CONTRACT: C19-2836-PW C.W. ROBERTS CONTRACTING, INC. PJ ADAMS WIDENDING PROJECT EXPIRES:07/12/2023

CHANGE ORDER FORM

Change Order No.: _____4

Description: (1) Incorporate utility adjustments at Villacrest and PJ Adams as shown in the attached sketch, a markup to Drawing Number 11 of the original work plans prepared by Atkins for the City of Crestview Utility Adjustments; (2) Field locate and install temporary 8 inch utility pipe to drainage structure \$-101 pursuant to resolution of RFI #16 (localized flooding); (3) Corrects typo in unit pricing stated in Change Order 3; (4) Adds twenty-five (25) weather/recovery days recommended by CEI as per contract for the period 1/1/22 - 4/30/22.

Attachments: Atkins Drawing Number 11 as Marked and Indentified as Change Order 4 (1 page); Breakdown of Work/Pay Items and Unit Costs (2 pages); Email correspondence dated 3/24/22 between Fu (Engineer) and Hunt (CEI) for resolution to RFI #16.

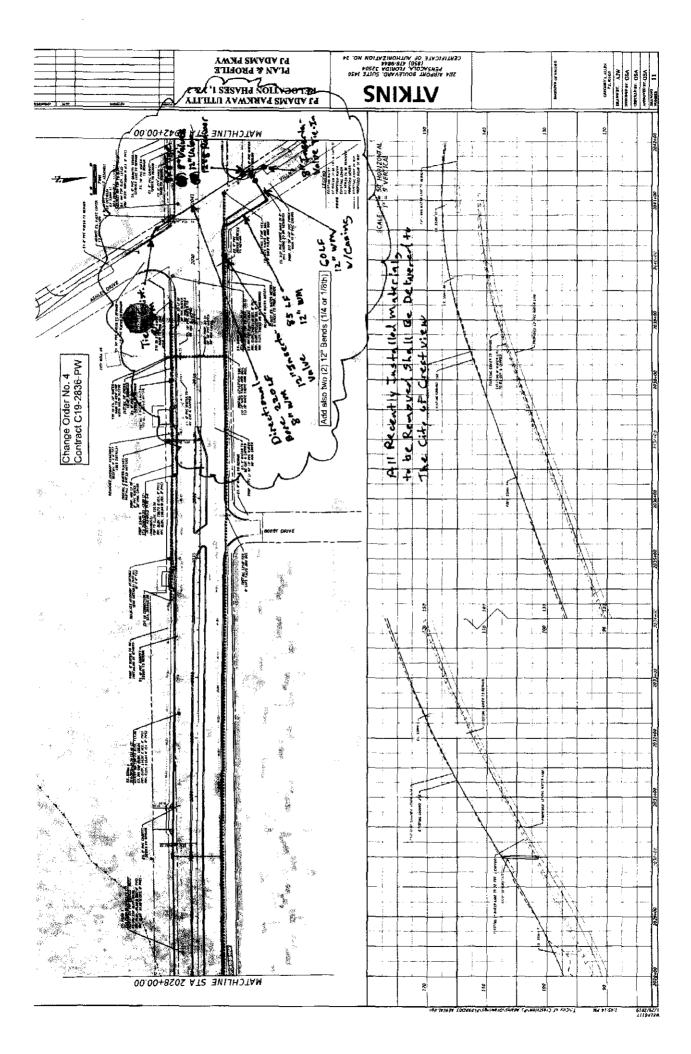
Utility Adjustments at Villacrest and PJ Adams:

FDOT Pay Item	Item Description		Qnty	U	nit Price	Cost	Note
1050-31-212	Utility Pipe, F&I, PVC, Water, 12"	LF	145	\$	72.65	\$ 10,534.25	1
1050-42-206	Utility Pipe, F&I, HDPE, Water, 8" DIRECTIONAL Bore (includes fittings)	LF	220	\$	117.63	\$ 25,878.60	1
1050-61-116	Utility Pipe - Steel, F&I, Casing 16" (12" WM)	LF	60	\$	210.30	\$ 12,618.00	2
1055-31-208	Utility Fittings, for PVC Pipe 8" and larger, TEE	EA	1	\$	926.75	\$ 926.75	1
1055-31-112	Utility Fittings, for PVC Pipe 12" and larger, Elbow	EA	2	\$	1,847.50	\$ 3,695.00	1
1055-31-312	Utility Fittings, for PVC Pipe 12" and larger, Reducer	EA	1	\$	1,552.81	\$ 1 ,552.81	1
1080-24-108	Utility Fixture, 8" Gate Valve, Assembly, F&I	EA	1	\$	2,747.90	\$ 2,747.90	1
1080-24-112	Utility Fixture, 12" Gate Valve, Assembly, F&I	EA	1	\$	4,822.30	\$ 4,822.30	1
1080-27-108	Utility Fixture, 8" Line Stop Assembly, F&I (Insertavalve)	EA	1	\$	12,041.80	\$ 12,041.80	1
1080-27-112	Utility Fixture, 12" Line Stop Assembly, F&I (Insertavalve)	EA	1	\$	27,395.10	\$ 27,395.10	1
